BEFORE THE
GEORGIA PUBLIC SERVICE COMMISSION

GEORGIA POWER COMPANY’S)	DOCKET NO. 56002
2025 INTEGRATED RESOURCE PLAN)

DIRECT TESTIMONY AND EXHIBITS

ON BEHALF OF THE
GEORGIA PUBLIC SERVICE COMMISSION
PUBLIC INTEREST ADVOCACY STAFF

Figure 1. Base Case Integration Costs

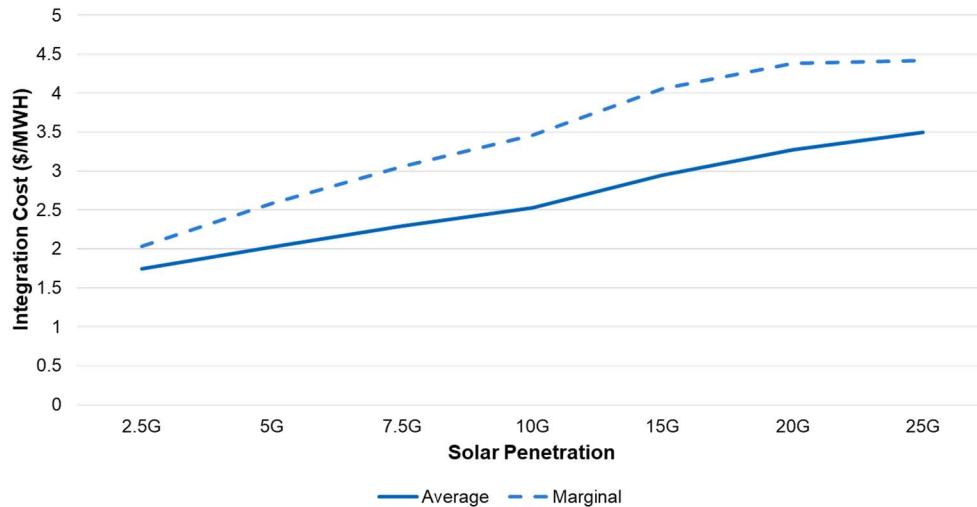
8 It is noteworthy that the Company’s 5,000 MW of solar scenario did not identify any
9 incremental system cost of managing the variability of that quantity of solar capacity (and
10 thus was excluded from Table 1), indicating that the system had sufficient flexibility to
11 respond to variability (Company Response to STF-PIA-3-24). However, the Company
12 decided to extrapolate the mitigation cost down to assign costs to lower amounts of solar,
13 even without supporting model results (Technical Appendix Vol. 2, Section 5, p. 7). That
14 extrapolation is reproduced below.
